## York Street Interchange

Vector Re Routing  
Proposal  
Assessment

November 2015

Drawing Number <b>DRAWING 1</b>	Rev <b>P02</b>
------------------------------------	-------------------

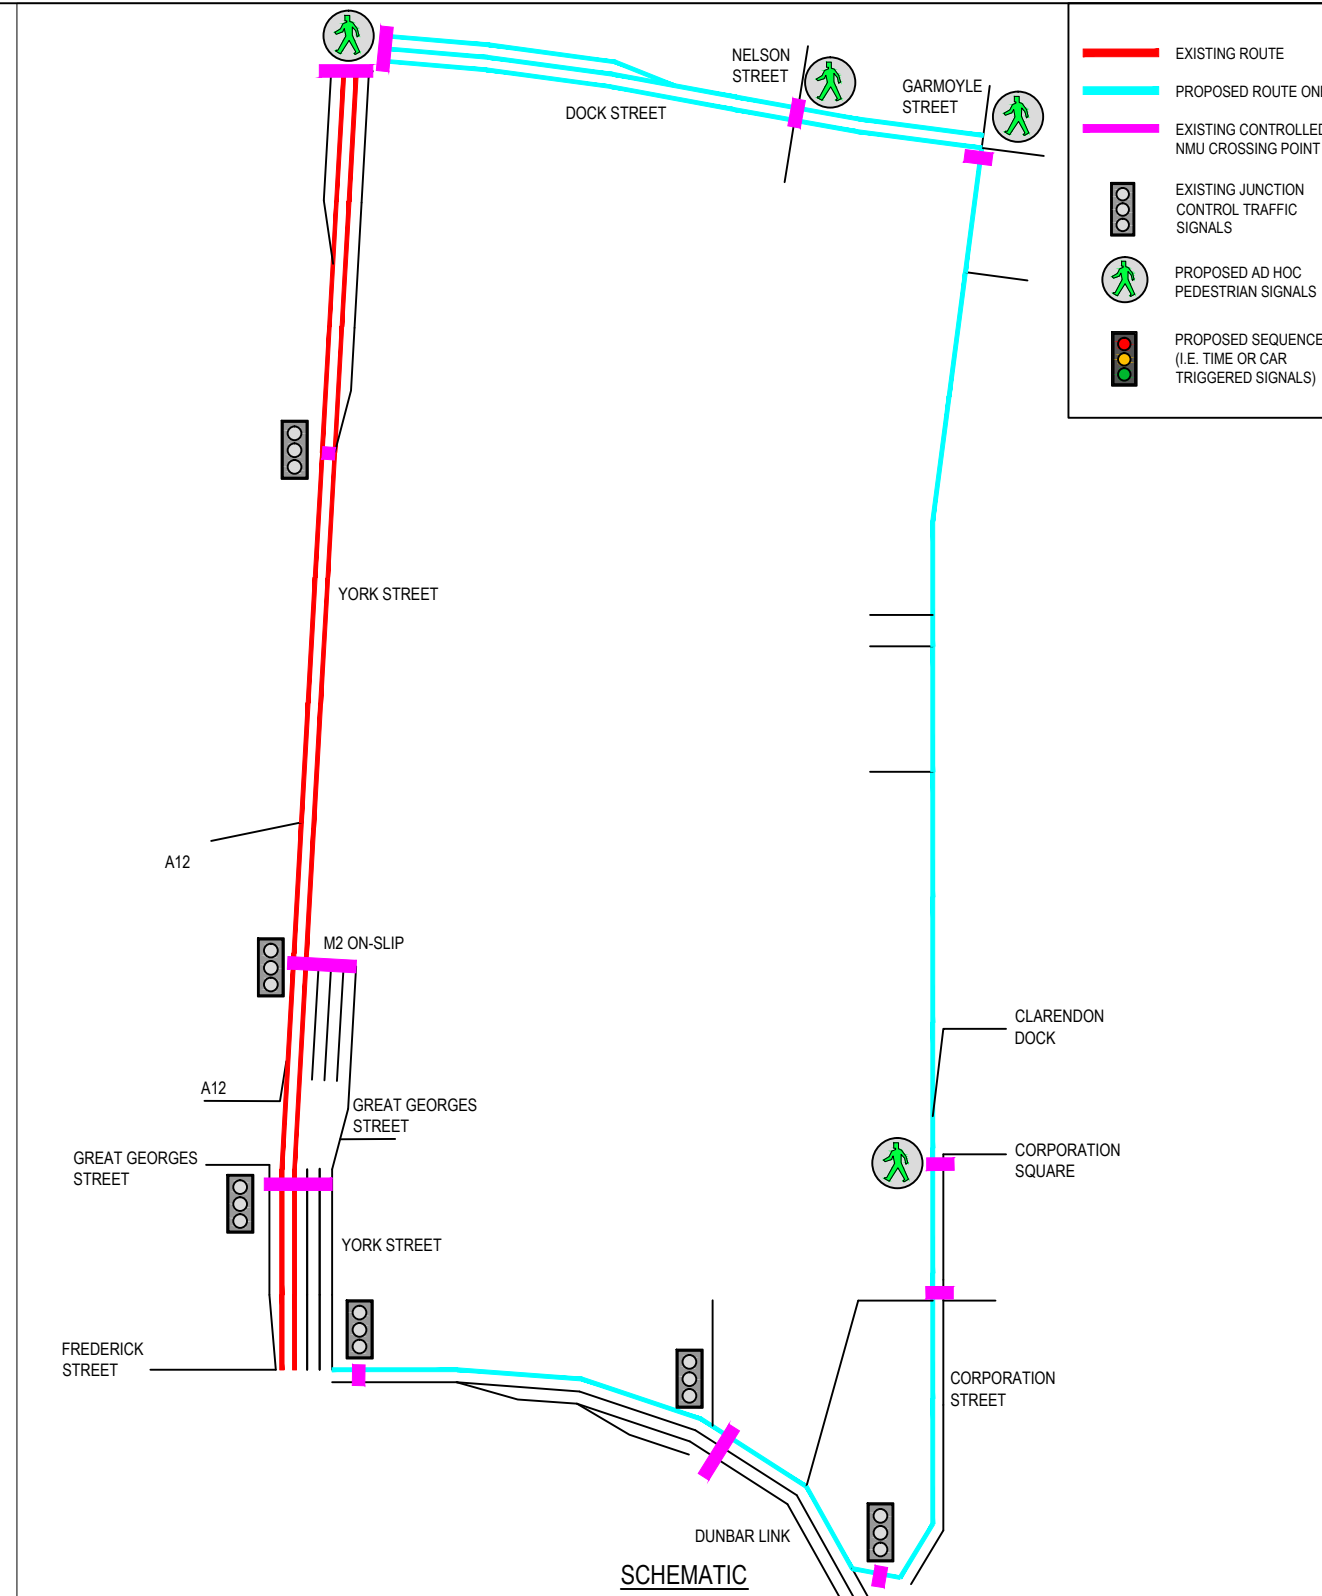
The Vector Proposal is based on creating free-flow routes to allow traffic to move in a more efficient manner. There are six routes in particular which will see significant change and these are described below. The six routes are illustrated on Drawing 1 in Appendix A.

DRAWING 3

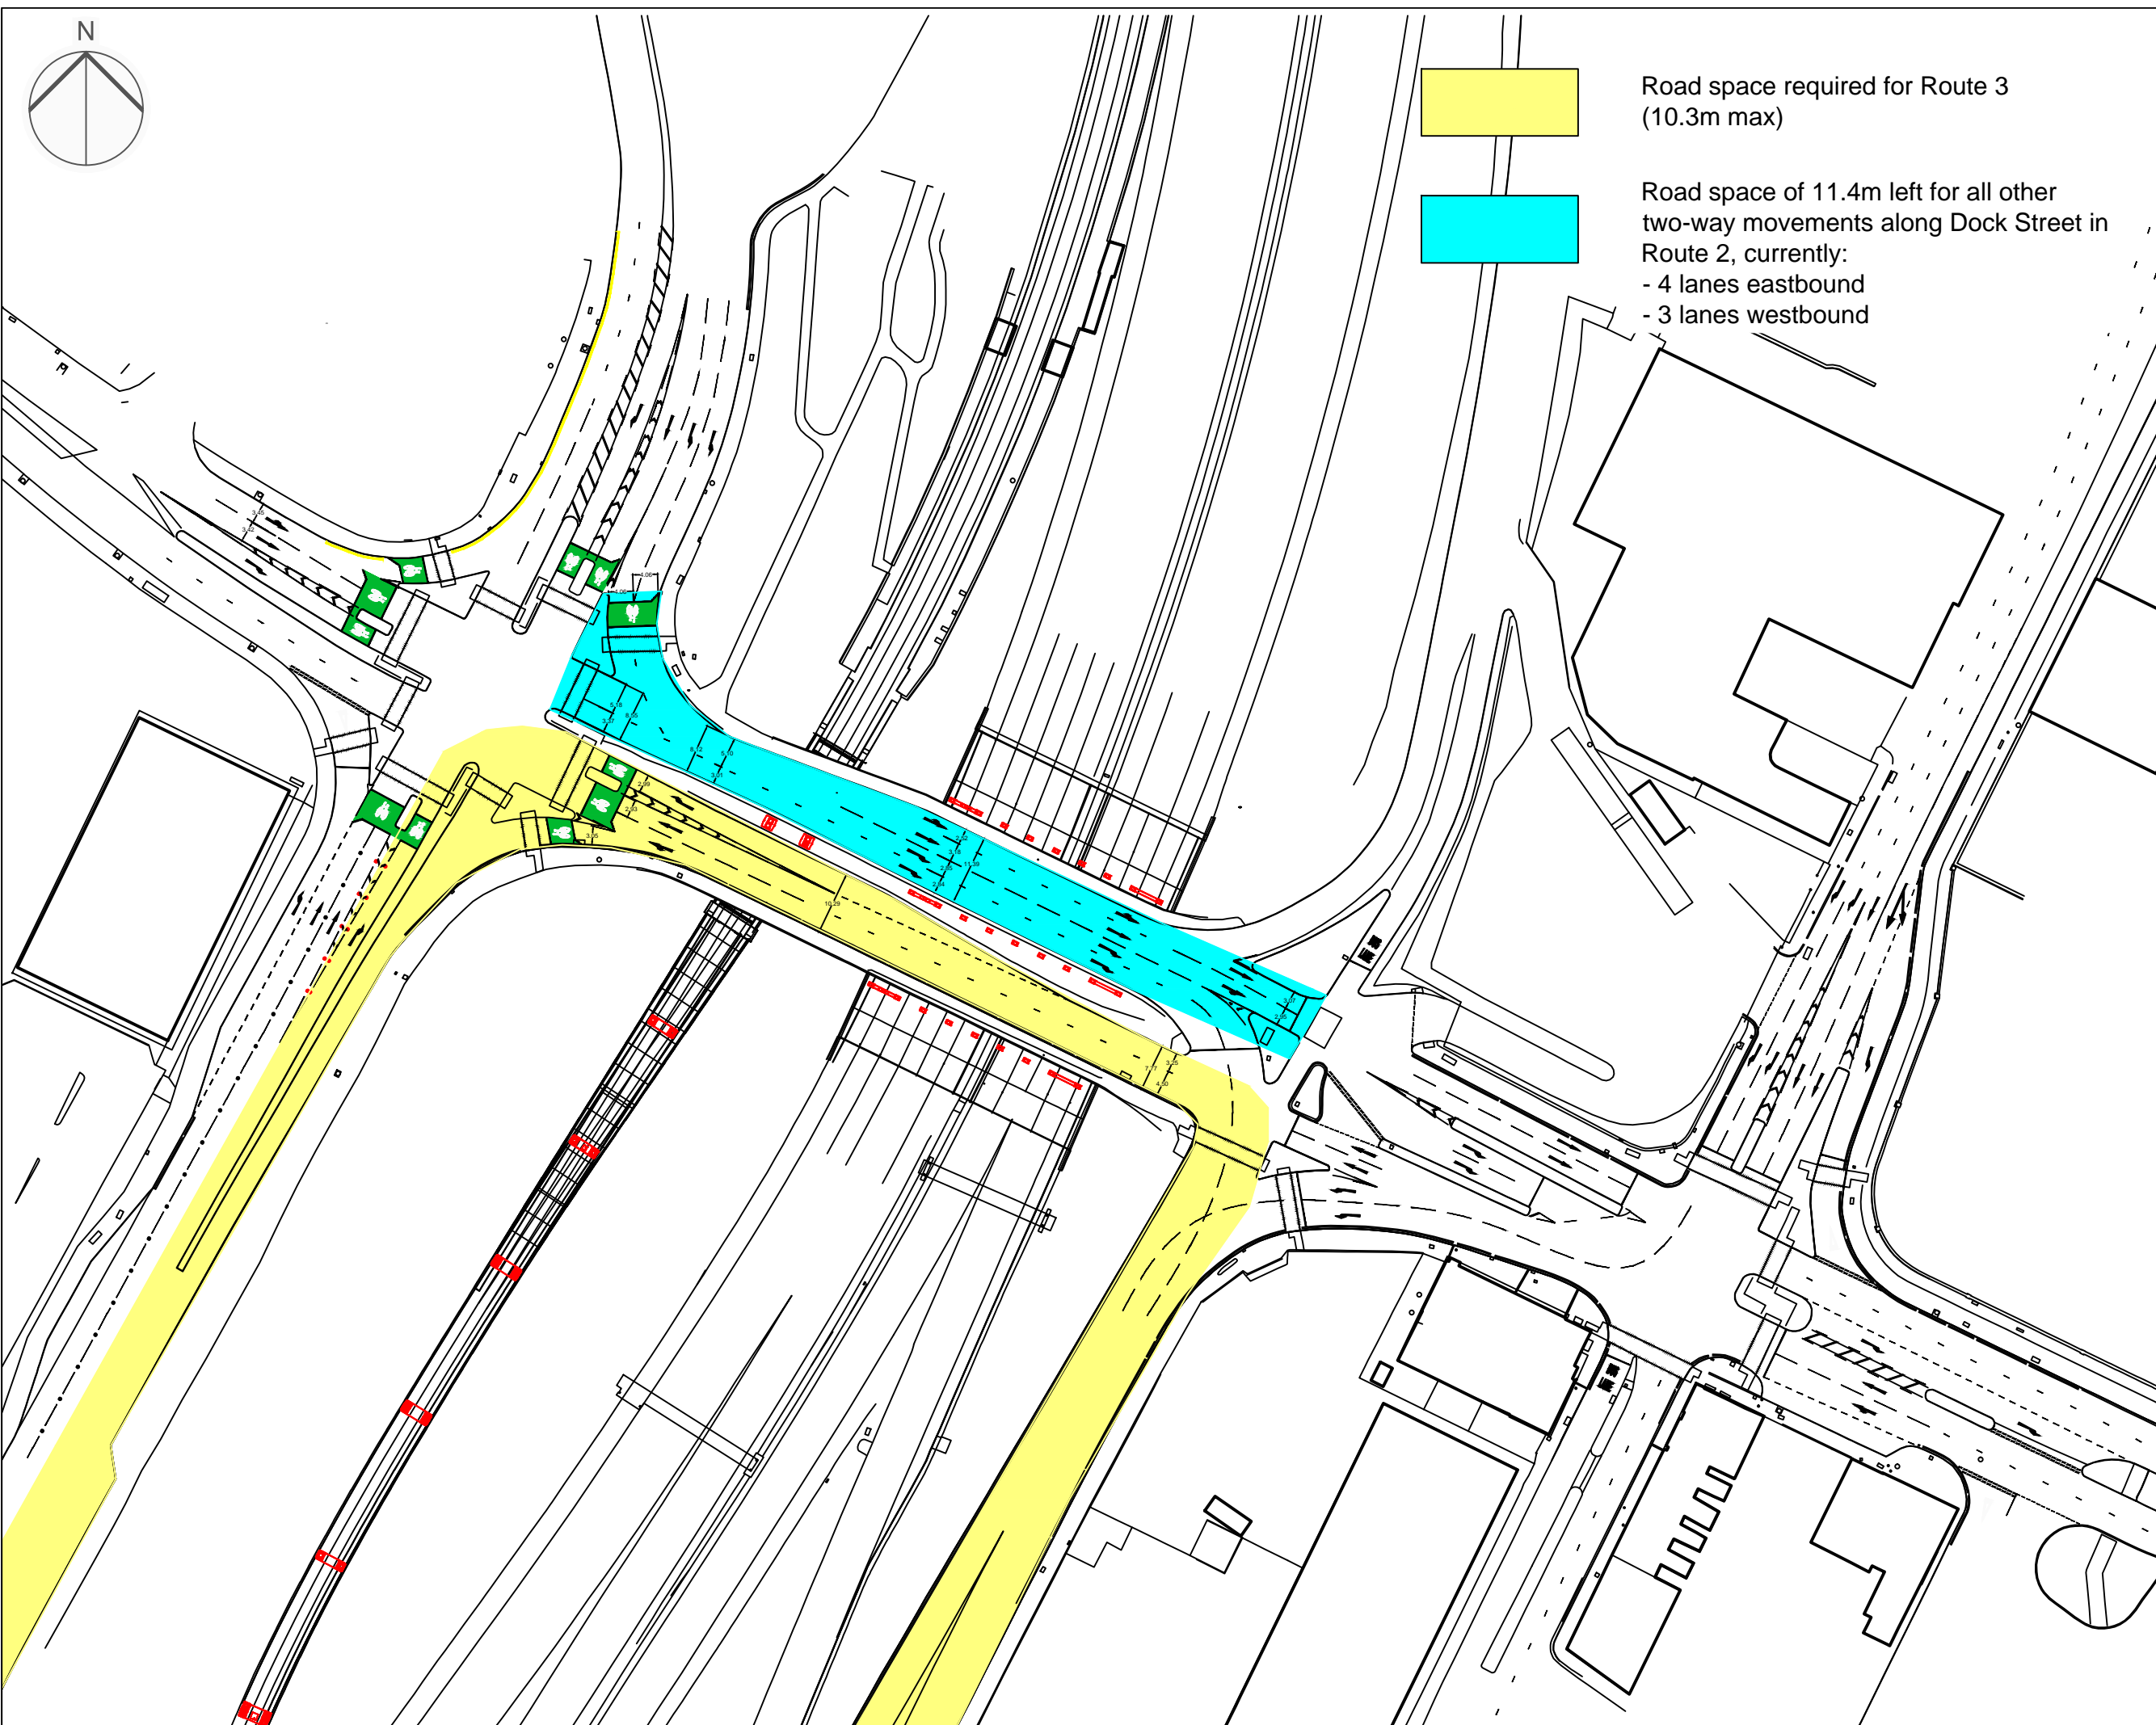
Drawing 3 in Appendix A illustrates the Vector Proposal, along with a schematic diagram illustrating existing lane provision on the original and diversion routes.

- With the future plans to develop City Quays, the re-routing of additional traffic flows onto Corporation Street are likely to have a detrimental impact on access to new residential and commercial properties.

- Within the span arrangements of the existing road and rail bridges at Dock Street, there would appear to be insufficient width to accommodate enough traffic lanes to cater for the anticipated re-routed flows. This is illustrated in Drawing 4 in Appendix A. It is considered that any loss of capacity would significantly increase congestion at these junctions on all approaches including, importantly, the main access from the M2 motorway to Belfast City Centre.

- If additional width is required on Dock Street to accommodate all traffic movements, it would be necessary to demolish both the existing bridges and replace these with new structures with longer span arrangements.

Drawing Number  
**DRAWING 6**

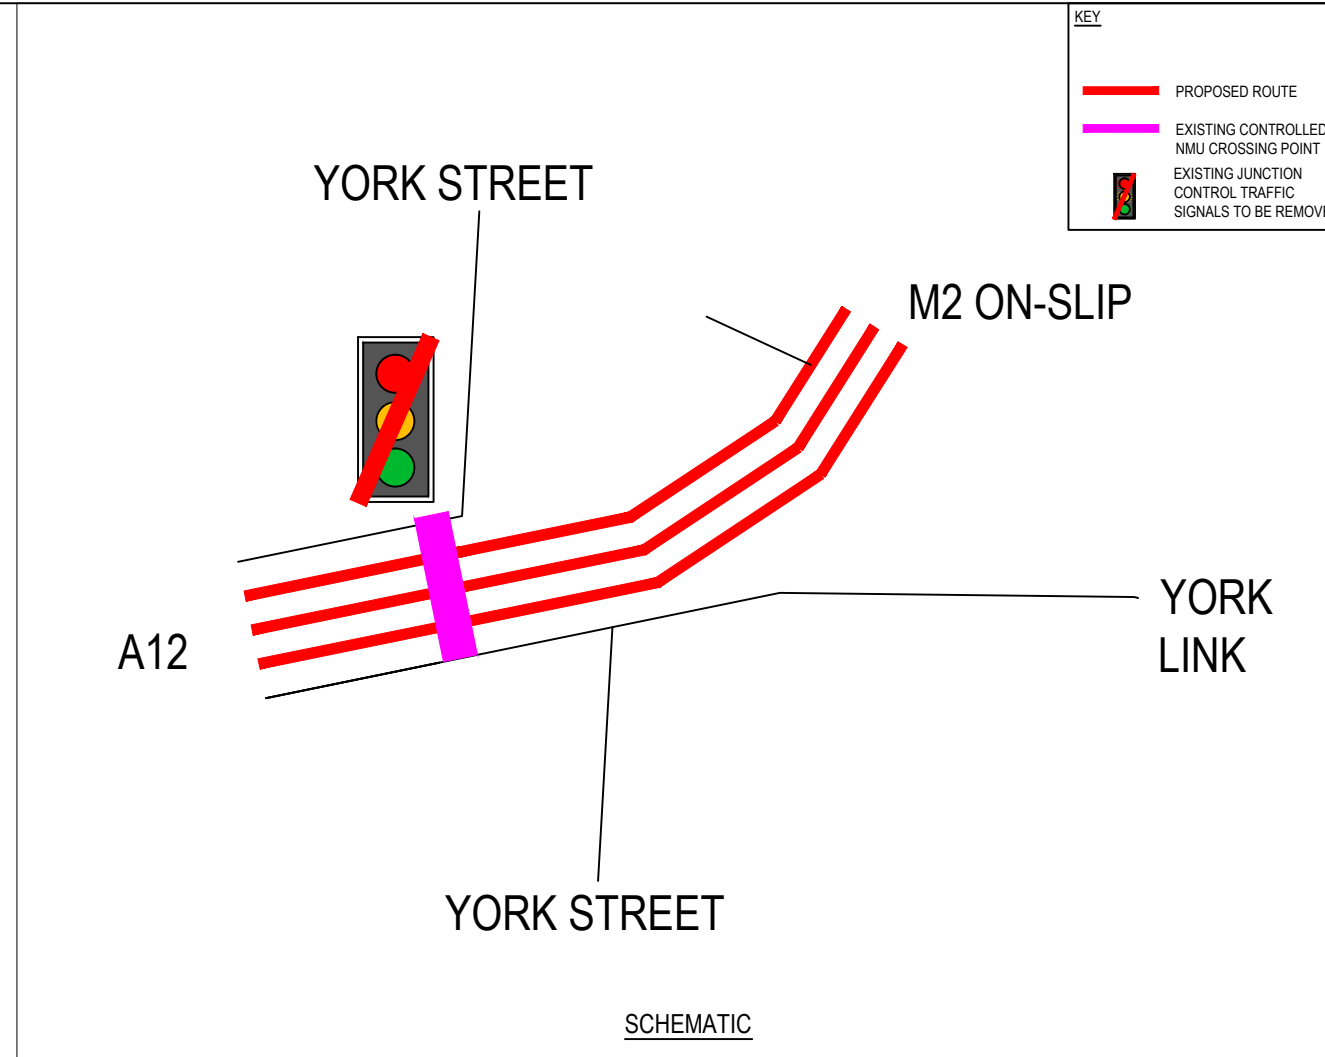
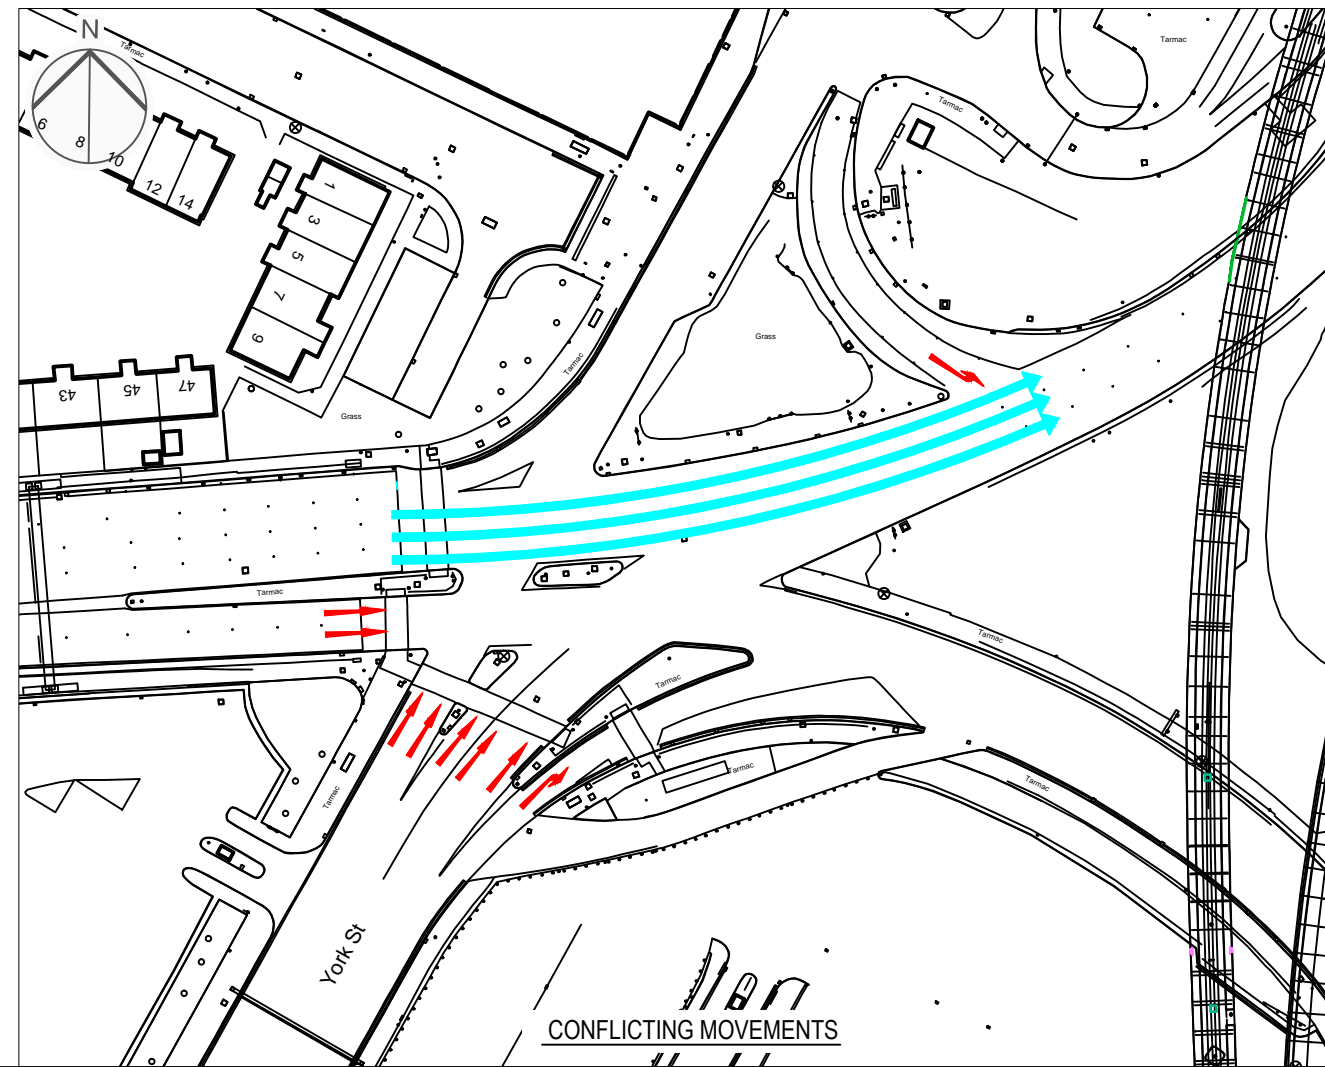
Drawing 6 in Appendix A illustrates the Vector Proposal, along with a schematic diagram illustrating existing lane provision on the original and diversion routes.
